100% Design Documentation

Lake Charlene Drainage Improvements
US 98 to Lake Joanne Drive

February 5, 2018

60% COUNTY COMMENT/RESPONSE

PLAN & PROFILE
S. 61 st. AVE.
STA. 30+00.00 - 35+40.00

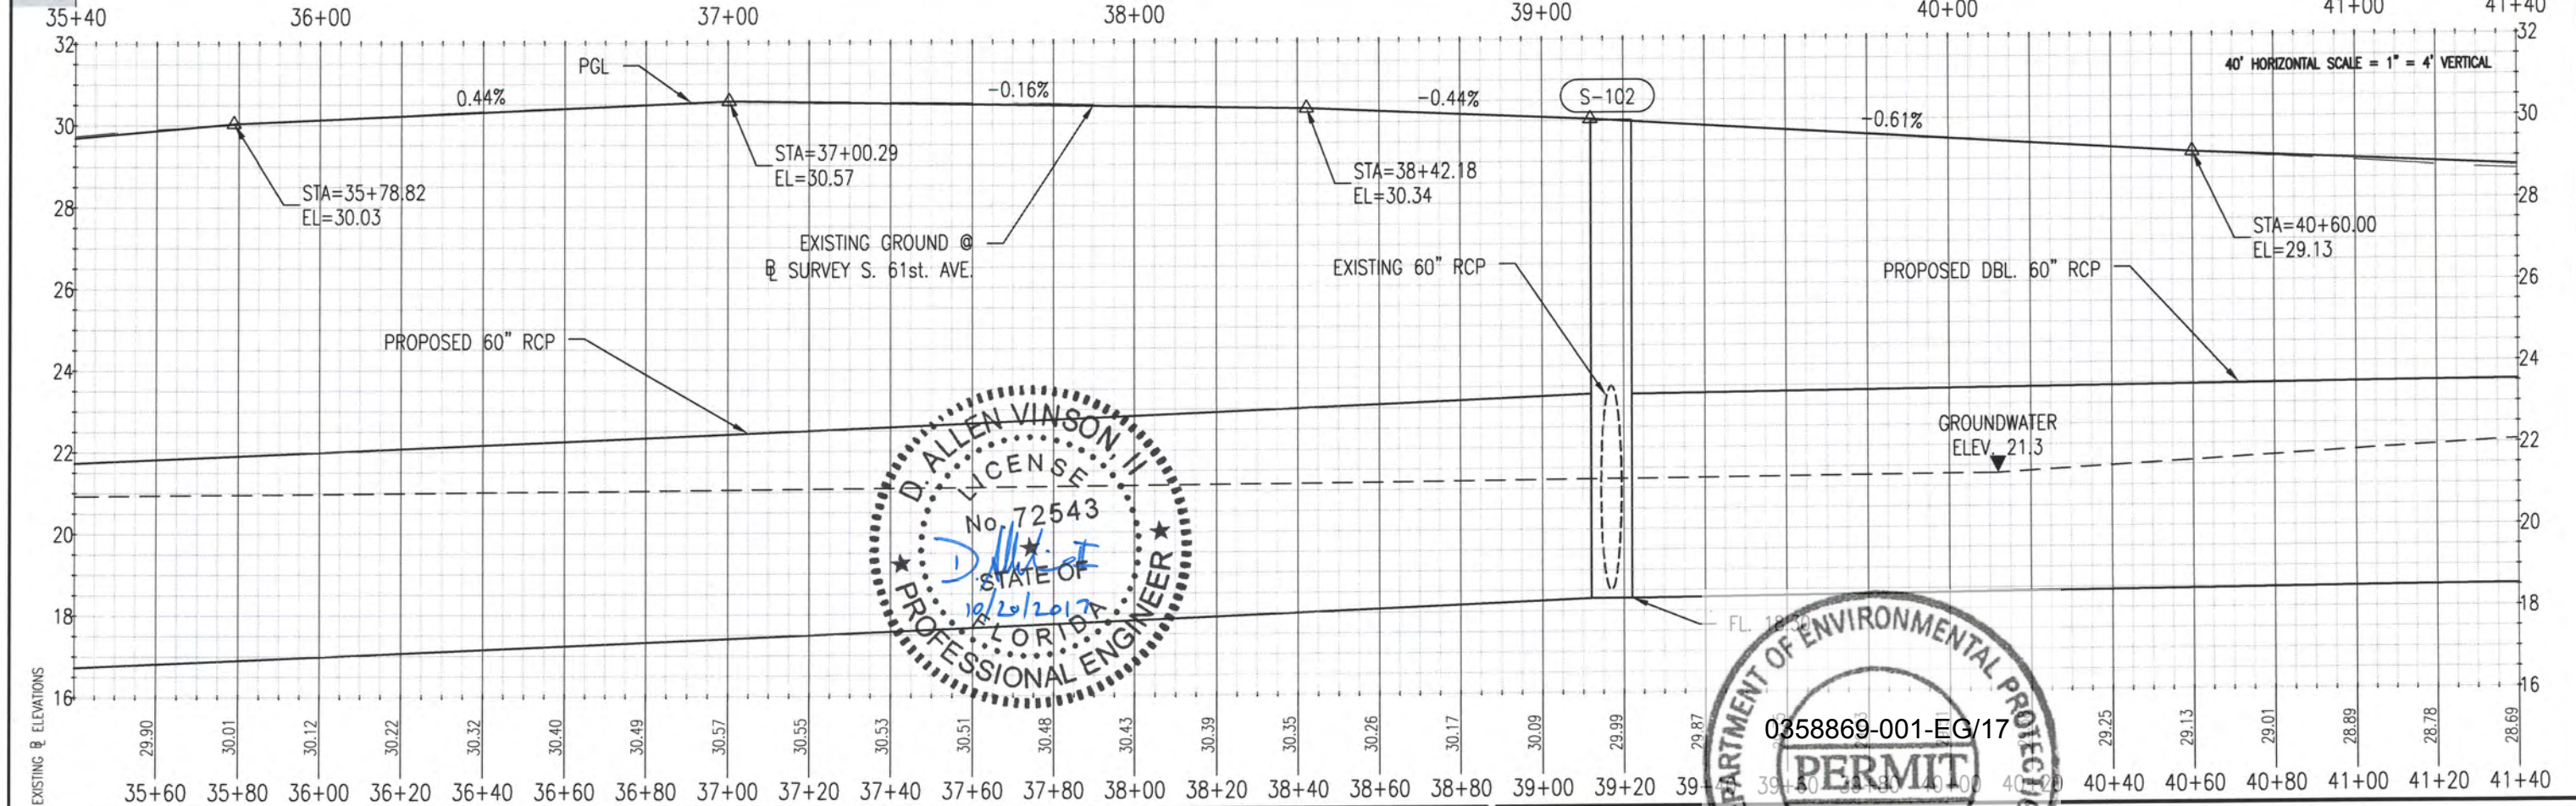
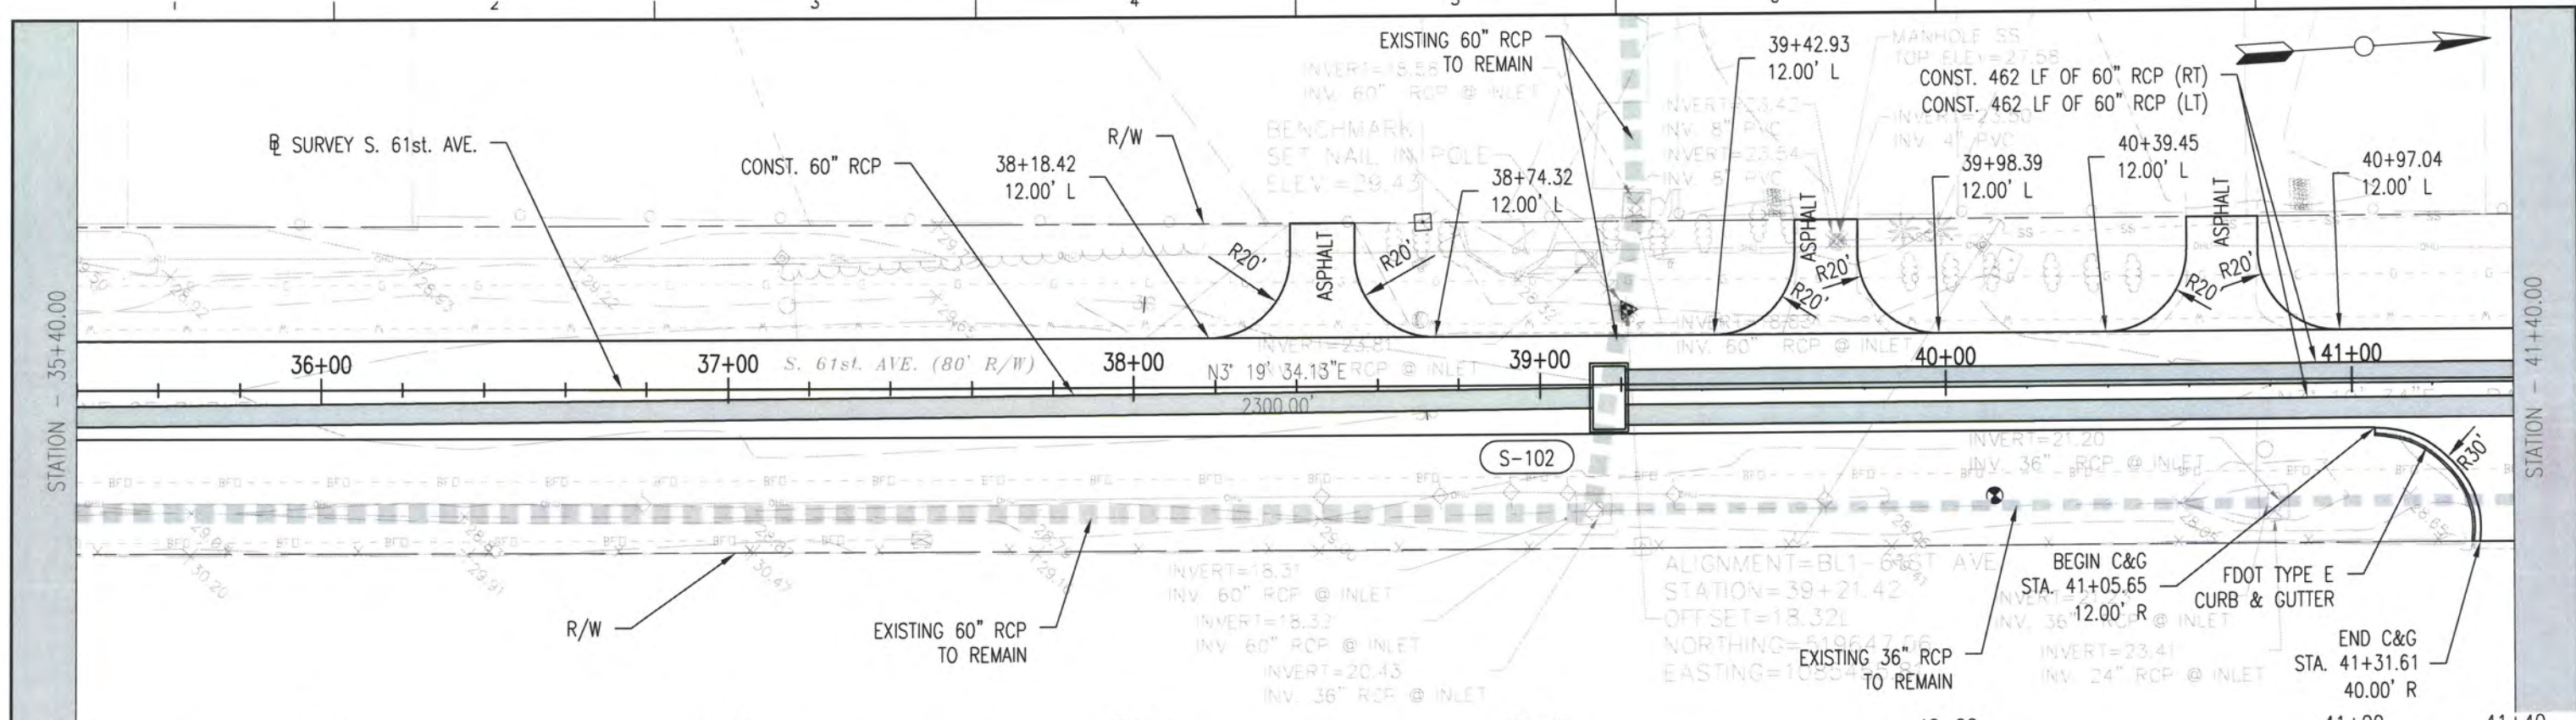
32		Is there a way to identify HWY 98 better on the drawings?	Agree. Designer will incorporate.	X		
33		Sheet 8 add invert information for inlet at station 33+60 west side.	Existing Invert is shown as gray survey label.			N/A
34		Sheet 8 do you need to label inlet at 32+60 west side?	This is an AT&T remote terminal box/pad.			N/A
35		Showing flow lines on inlets would be helpful.	Please clarify "on inlets". Flow arrows are shown for proposed pipe in cross sections.			Discuss
36		S-101 Do you need the pipe connection on the East side or can we remove the connection by vacating the pipe or removing the pipe and sealing the existing east structure?	H&H modeling leaves all connections to existing structures in place in order to evenly spread the flow into the outfall system. Design intent also seeks to avoid work on shoulders where utilities are located where possible.			N/A
37		S-102 is the existing pipe the same elevation? What is the plan to handle the water? Does the east pipe need to flow into the existing pipe and the western pipes flow into the new one?	H&H modeling leaves all connections to existing structures in place in order to evenly spread the flow into the outfall system.			N/A

S-200

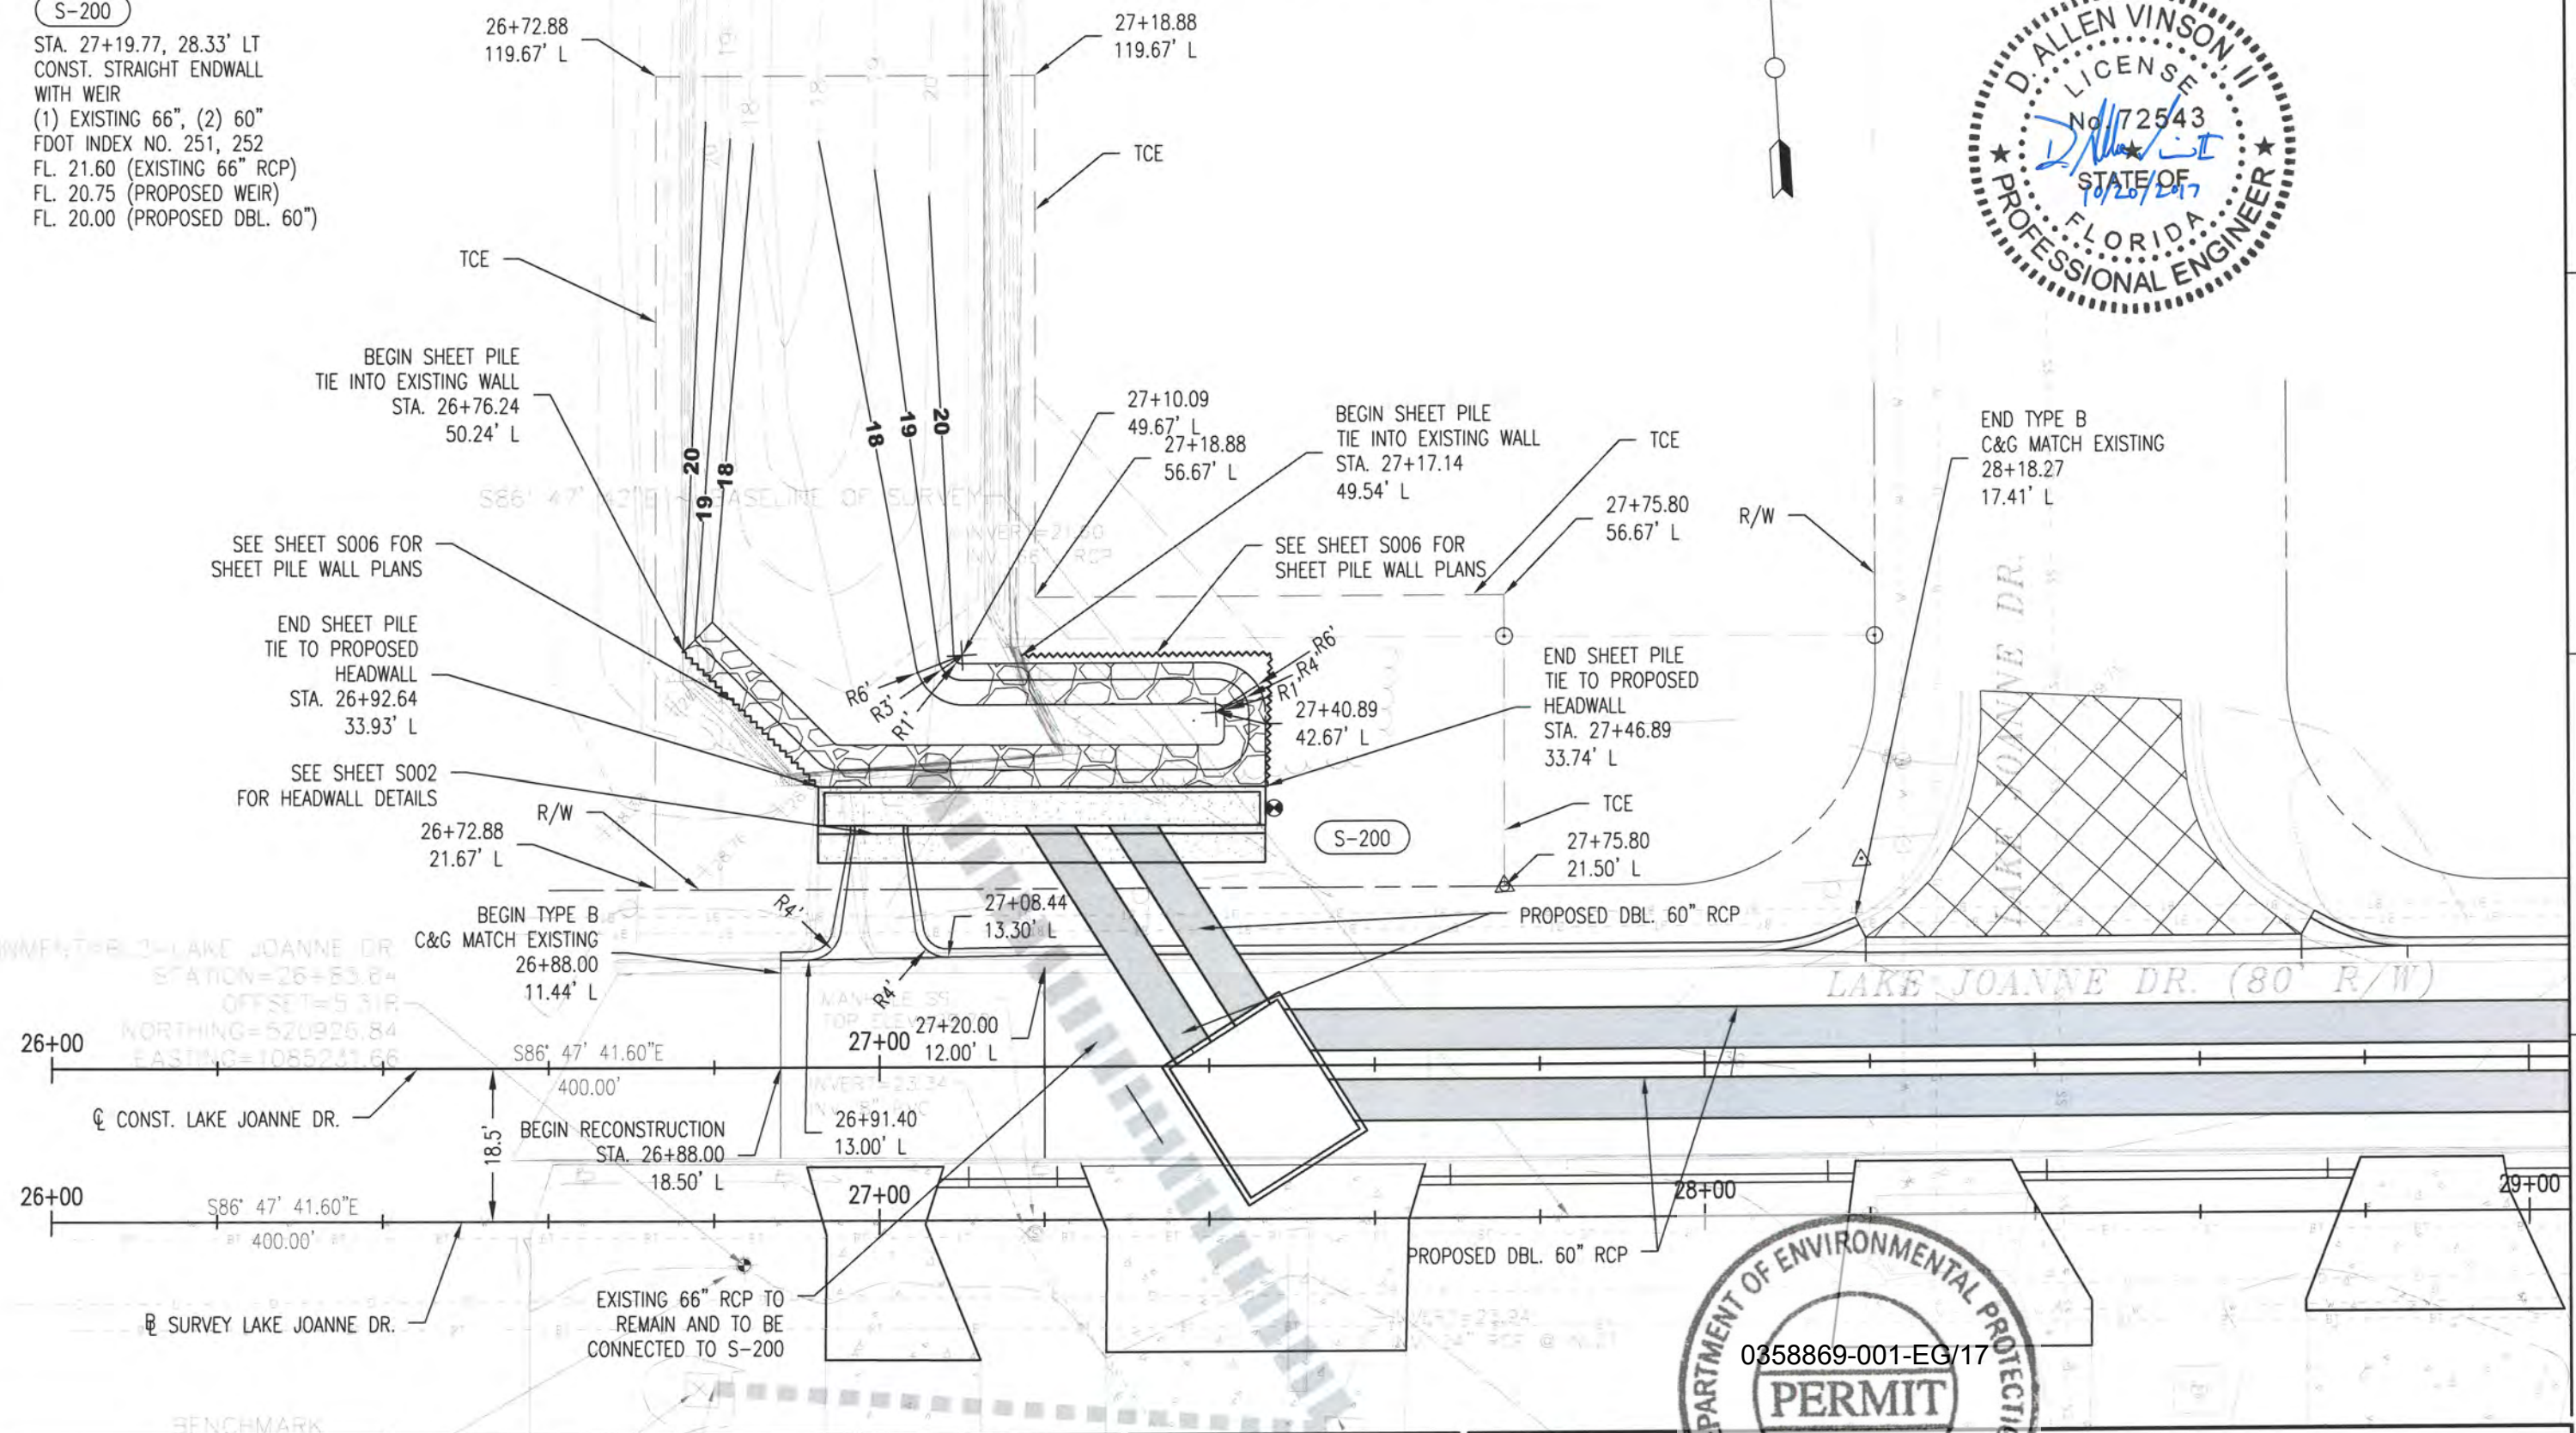
25		Add drawing showing how existing pipe will be connected to S-200.	Agree. Designer will incorporate in next submittal as part of the structural plans.	X		
26		Where is S-200 detail?	Designer will incorporate S-200 detail in next submittal as part of the structural plans.	X		
27		Sheet 13 – Add label for S-201 for clarity.	Agree. Designer will incorporate.	X
